Product Change Notification

Date Issued :	December 04, 2025	PCN Number :	517622
Reason for Change :	Packaging Method/Quantity Changing		
Description of Change :	This notification is to inform you about part(s) listed will undergo changes for PU foam to EPE Foam. No changes will be made to product as part of this change.		
Assessment of Change :	Drop Test		
Planned Implementation Date :	June 04, 2026		
Customer Sample Availability Date:	December 31, 2025		
Last date to request Samples by Customer :	December 30, 2025		
Please note if Samples are not requested as per Customer Samples Request date, it may take additional 4-6 weeks to arrange Samples.

(Before: PU FOAM)

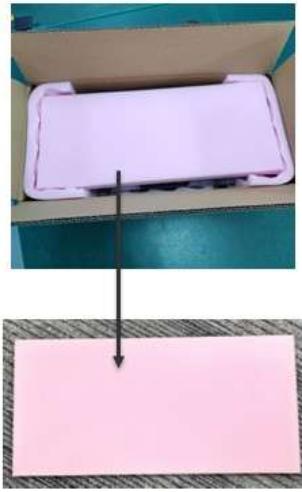
- Change PU foam material to EPE, EPE has better shock absorption and buffering effects, is more widely used in electronic product protection, and is more environmentally friendly.
- Product Impact: no impact on product.
- Part Number Impact: All products using PU foam packaging materials.
- Optimize packaging.
